Subject: Growing Baldock Modelling Approach Note

Appendix D – Road Safety Assessments and Designers Response

ITP, a company of Royal HaskoningDHV, has been appointed by Urban & Civic to undertake a Stage 1 Road Safety Audit. The Audit relates to highway works associated with a proposed development in Baldock, North Hertfordshire. The location of the highway works subject to this Stage 1 Road Safety Audit are shown in **Figure 1** of this report.

Image 1: Extracts from PC7029-RHD-CE-GB-DR-D-0114 S3 I02, showing a red blister tactile paving layout at the crossing face (suggesting a controlled crossing) on Royston Road.

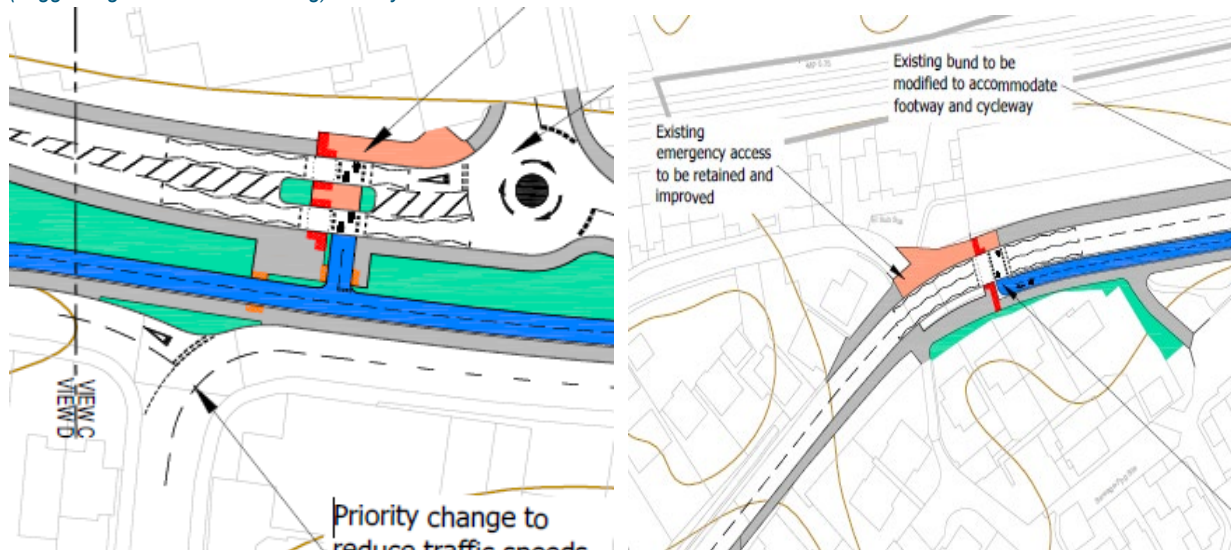
Description: Drawings provided to the Audit Team detail the general arrangement of the proposals at the abovenamed roads, including the provision of pedestrian crossings. From the drawings provided, the Audit Team cannot confirm the types of crossings to be provided at some of the locations.

The drawings provided suggest that red blister tactile paving and road marking pertinent to a signalised crossing would be provided at the crossing locations. However, the Audit Team cannot confirm whether the crossing facilities would be controlled or not. As such, the Audit Team is concerned that the provision of inappropriate tactile paving in accordance with the type of crossing could result in road user confusion, which could subsequently result in collisions between road users.

It is recommended the proposed pedestrian crossing type should be established at these locations. Should the proposed pedestrian crossing types at these locations not be signalised, it is recommended that the proposed layout (including tactile paving and road markings) should be revised.

Image 6: Extract from PC7029-RHD-CE-GB-DR-D-0117 S3 I02, showing the inconsistency between the tactile paving at the crossing face of the shared use facility and the footway.

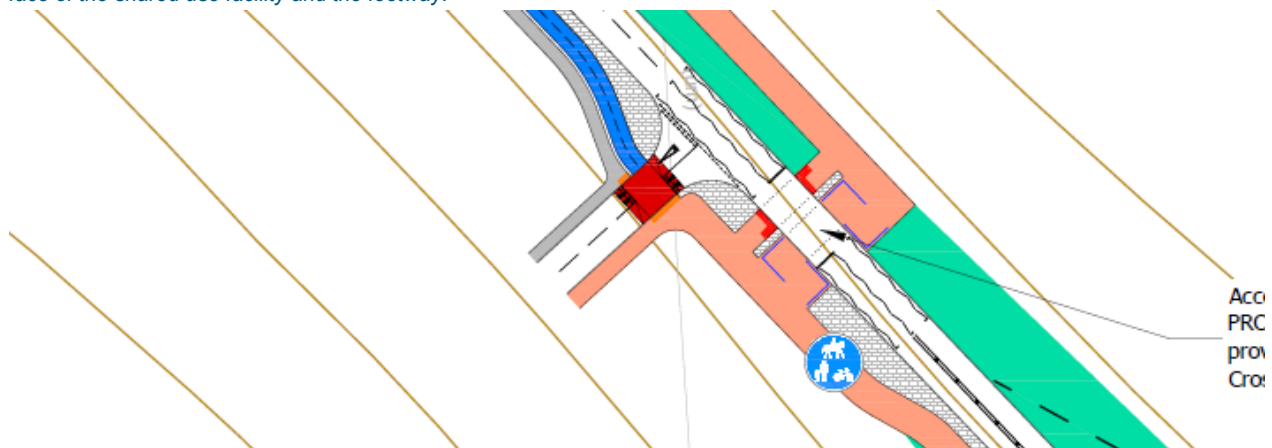
Description: Drawing PC7029-RHD-CE-GB-DR-D-0117 S3 I02 provided to the Audit Team details the general arrangement of the proposals at the location, including the provision of a pedestrian crossing between a shared use facility and a segregated footway and cycleway.

The Audit Team observed that the extent of the corduroy tactile paving proposed at the crossing face of the shared use facility is not consistent with the extent of the footway and could result in visually impaired users walking onto the cycleway. As such, the Audit Team is concerned that this could result in collisions between road users.

Image 8: Extract from PC7029-RHD-CE-GB-DR-D-0113 S3 I02, showing the lack of blister tactile paving at the crossing face on Royston Road (in red)

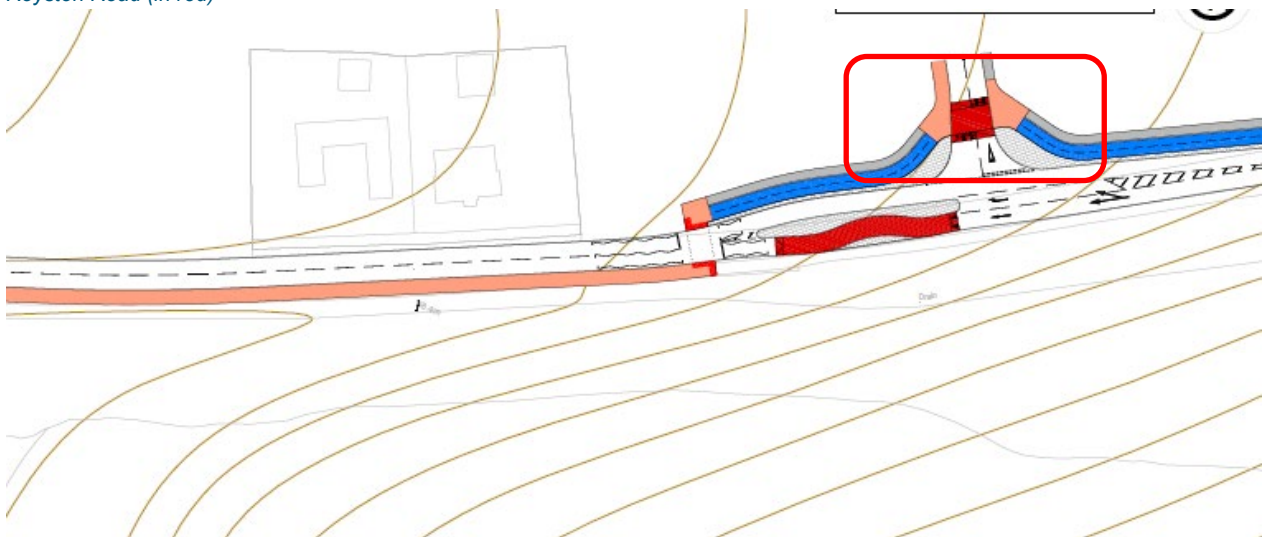
Description: Drawings provided to the Audit Team associated with the abovenamed locations detail the proposed general arrangement of the scheme, including the provision of blister tactile paving at the proposed crossing faces. From the drawings provided, the Audit Team consider the proposed tactile arrangement to be insufficient as blister tactile paving are not proposed at some of the crossing faces.

The Audit Team is concerned that the insufficient tactile arrangement could result in confusion for visually impaired users navigating the facilities, leading to the increased likelihood of collisions between road users.

Image 13: Extract from PC7029-RHD-CE-GB-DR-D-0116 S3 I02, showing the lack of corduroy tactile paving at the extents of the shared-use facility on the Aswell Road connector (in red)

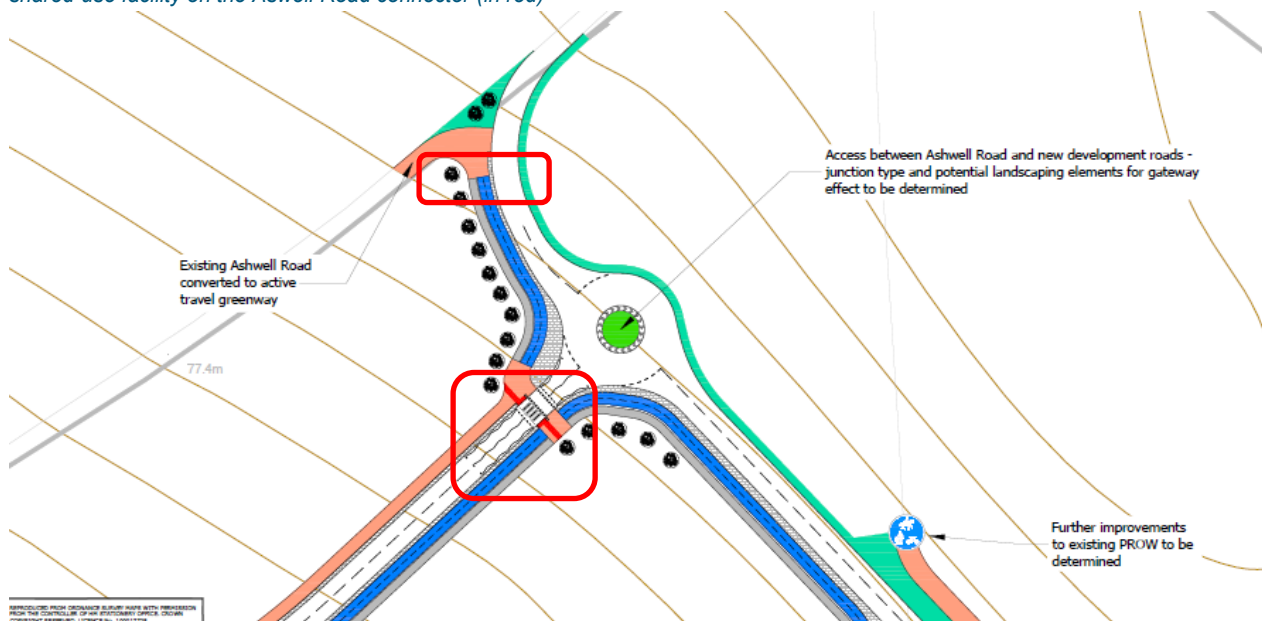
Description: Drawings provided to the Audit Team associated with the abovenamed locations detail the proposed general arrangement of the scheme, including the provision of shared use facilities across the proposed scheme. From the drawings provided, no transition facilities (such as corduroy tactile paving) have been provided to alert pedestrians navigating between the proposed shared use facilities that they are entering or exiting a shared-use facility.

The Audit Team is concerned that a lack of awareness of the shared use facilities could result in collisions between road users, particularly considering visually impaired users.

It is recommended that appropriate transition facilities such as corduroy tactile paving and signage be provided at the extents of the shared use facility to alert pedestrians accordingly, reducing the risk of collisions between road users.

Image 21: Extract from PC7029-RHD-CE-GB-DR-D-0113 S3 I02, showing the lack of corduroy tactile paving at the extents of the shared-use facility on Royston Road (in red)

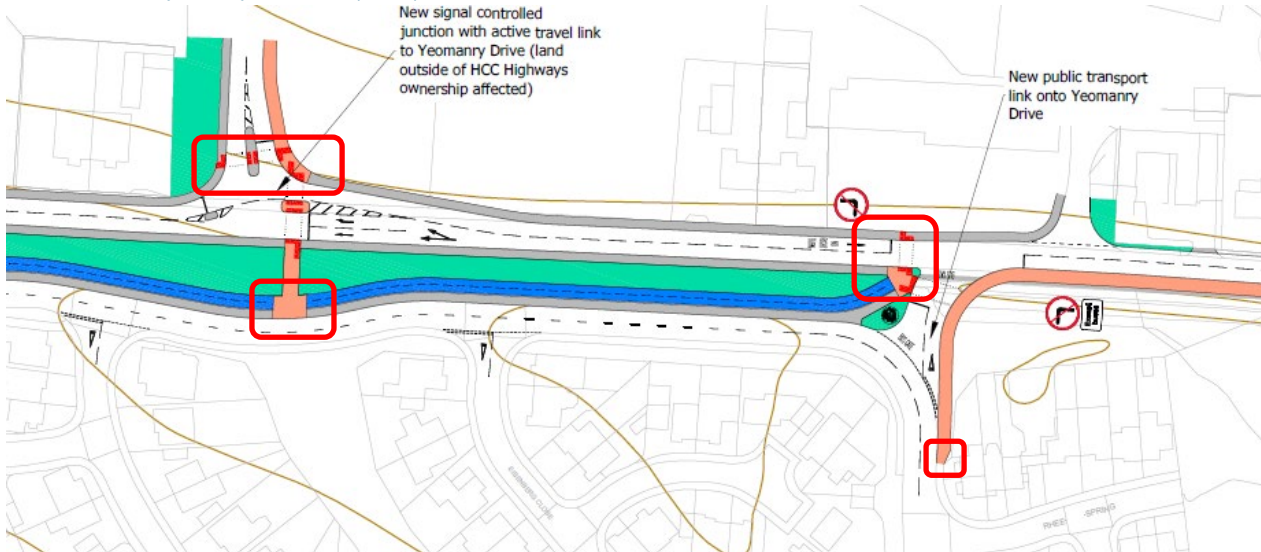
Image 20: Extract from PC7029-RHD-CE-GB-DR-D-0113 S3 I02, showing the lack of corduroy tactile paving at the extents of the shared-use facility on Royston Road (in red)

Image 25: Extract from PC7029-RHD-CE-GB-DR-D-0117 S3 I02, showing the lack of sufficient blister tactile paving at the extents of the Pegasus crossing on the new development corridor railway bridge (in red)

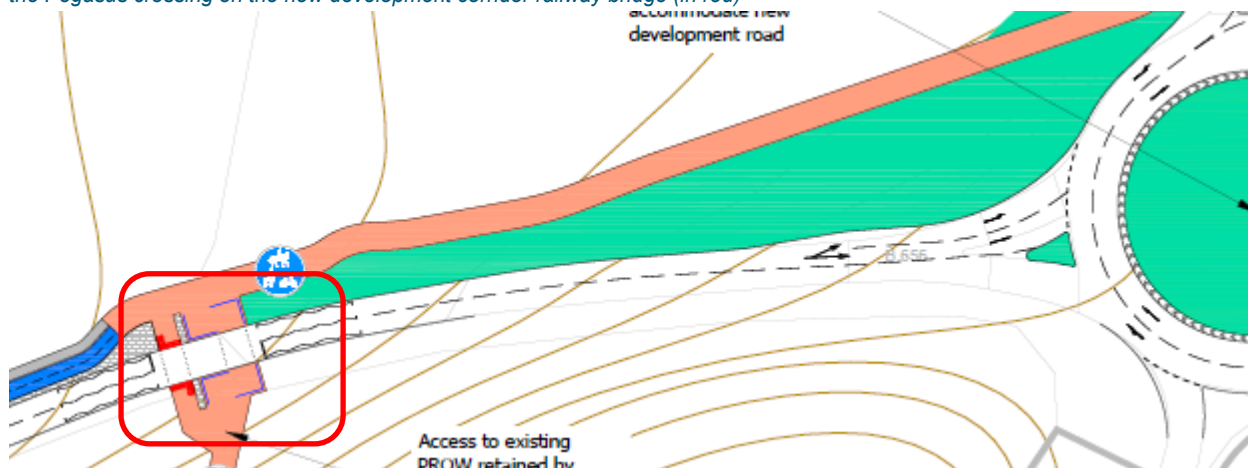
Description: Drawings provided to the Audit Team detail the general arrangement of the proposals at the abovenamed roads, including the provision of Pegasus crossings. From the drawings provided, the Audit Team observed that the stem of the proposed blister tactile paving at the crossing faces do not extend to the back of the shared facility. As such, the Audit Team consider the tactile paving arrangement at these locations to be insufficient.

The Audit Team is concerned that the insufficient tactile arrangement could result in confusion for visually impaired users navigating the facilities, leading to the increased likelihood of collisions between road users.
